Recall Bulletin

SB-10056213-7302

PRODUCT EMISSION RECALL

SUBJECT: Oxygen Sensor Fracture

3795711

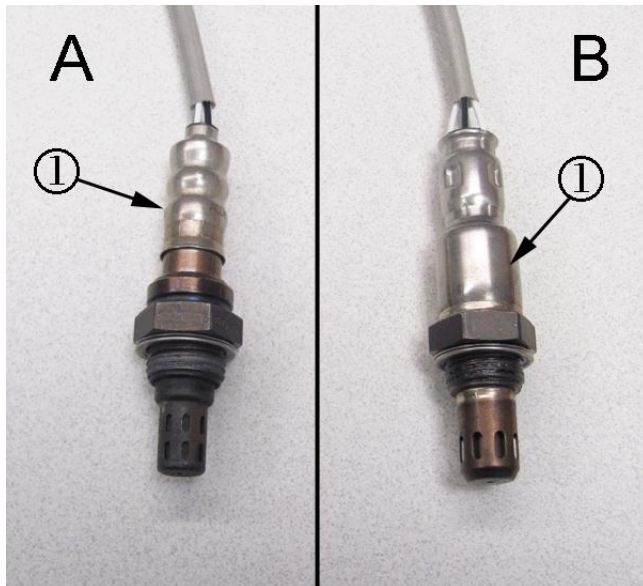
(A) First Design Heated Oxygen Sensor (B) Second Design Heated Oxygen Sensor (1) Location of Part Number

3. Determine if a first design (A) or second design (B) heated oxygen sensor is installed using a light and mirror.

- If a second design (B), P/N 12637297, heated oxygen sensor is installed, no further action is required. Lower the vehicle. Refer to *Lifting and Jacking the Vehicle* in SI.
 - If a first design (A), P/N 12656071 or P/N 12612571, heated oxygen sensor is installed, remove the sensor and replace it with a second design heated oxygen sensor. Refer to *Heated Oxygen Sensor Replacement –Bank 2 Sensor 2* in SI and *Heated Oxygen Sensor Replacement –Bank 1 Sensor 2* in SI.
4. After installing the new heated oxygen sensors, reprogram the ECM. Refer to *Engine Control Module Programming* in this bulletin.
